SOUTH PARK COMMONS

MASTER DEVELOPMENT PLAN

MDP PLAN NO.: 032-07

Re: **South Park Commons** **MDP # 032-07**

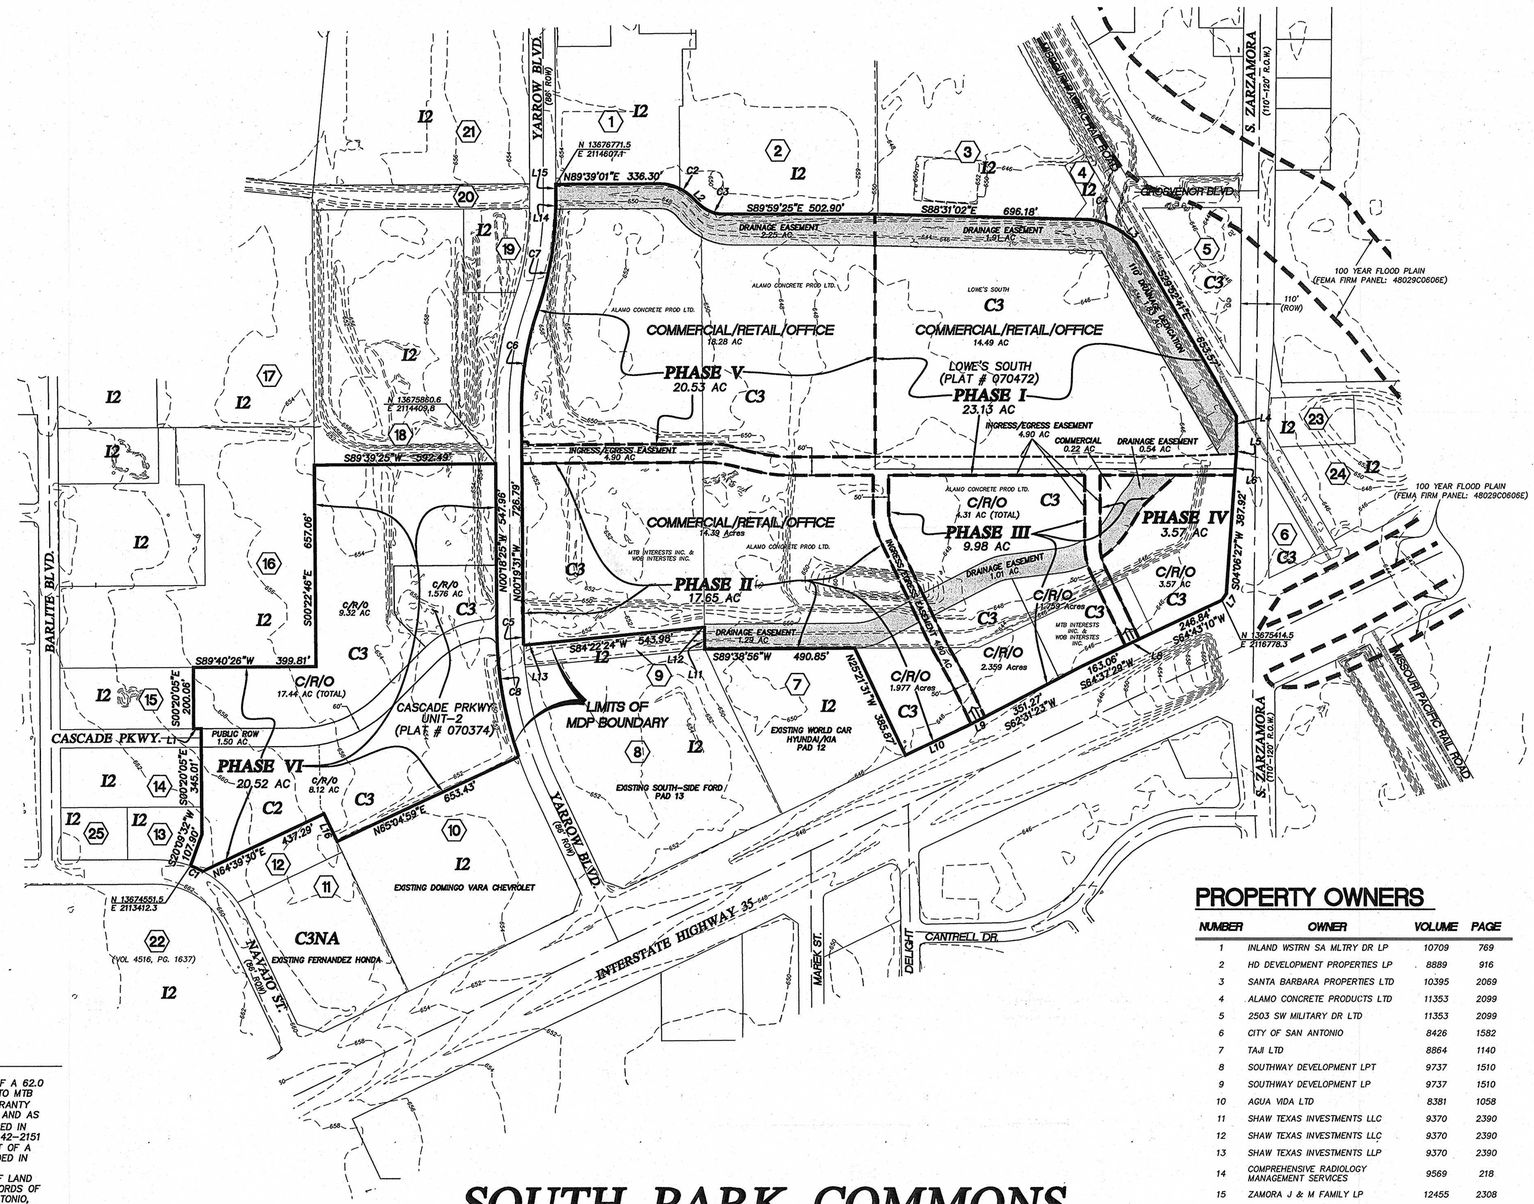
In consideration of public safety and convenience, excessive grades by reason of topography should be avoided in street layouts and arrangements. Any access and R.O.W. issues along state facilities will need to be resolved with the **Texas Department of Transportation (TXDOT)**. For information about these requirements you can contact TXDOT at (210) 615-5814.

- All commercial driveways for this project shall comply with Unified Development Code (UDC) §35-506, (r) Access and Driveways.
- All access driveways shall provide clear sight distance along Yarrow Blvd., Zarzamora St., S.W. Military Dr. and IH-35 to provide adequate obstruction free viewing distances for approaching traffic. All signage, landscaping, and improvements shall be selected and located so as to not block these clear sight distance areas.

- Provide a traffic signal warrant study and provide appropriate signalization if warrant(s) are met at the intersection of S.W. Military Drive and Yarrow Blvd.

- Widen the S. Zarzamora southbound approach at the IH-35 Southbound Frontage Road to provide three through lanes and a short channelized right-turn lane.

- The developer shall be responsible for providing right-turn deceleration lanes with storage lengths and bay taper in all the following driveway access points:

a) Yarrow Blvd at Driveway A,

b) IH-35 Southbound Frontage and Driveway C,

c) IH-35 Southbound Frontage Road and Driveway D and

d) Yarrow Blvd. at Driveway E

The developer shall be responsible for providing right-turn deceleration lanes with storage lengths and bay taper in all the driveway access points along IH-35 Frontage Roads as approved by TX DOT as it relates to the submitted TIA traffic counts, Unified Development Code (UDC) §35-502 (a)(7), subsection C.

- The developer should provide adequate width to accommodate two outbound lanes and a single inbound lane at all driveways except those along the IH-35 Southbound Frontage Road.
- Driveways C and D along the IH-35 Southbound Frontage Road should have a single exit lane due to the one-way operation of the frontage road.
- All driveways should have a minimum curb radius of 25 feet.
- The developer shall coordinate with Union Pacific Railroad for driveway access points for approval where appropriate.
- Coordinate with TxDOT in regard to location of proposed Driveway C and D in regard to the close proximity of existing off-ramp from IH-35 to minimize risk to drivers entering and exiting the proposed driveway.

- 2006 Tree Preservation ordinance standards per UDC §35-523 – a Tree Preservation Plan is required prior to any work on site. This can be submitted either as a site work permit or at the platting stage. No site work is permitted at this stage.

- Landscape ordinance per UDC §35-511. It appears some landscape points can be met by preserving existing vegetation as well as meeting any mitigation requirements (either through preservation of smaller material or transplanting). Recommend securing knowledgeable Landscape Architect at planning and design phase to better utilize existing trees and vegetation. Preservation will eliminate the need for irrigation. Staff would be willing to meet with developer at design stage to assist with tree preservation and landscape plan.
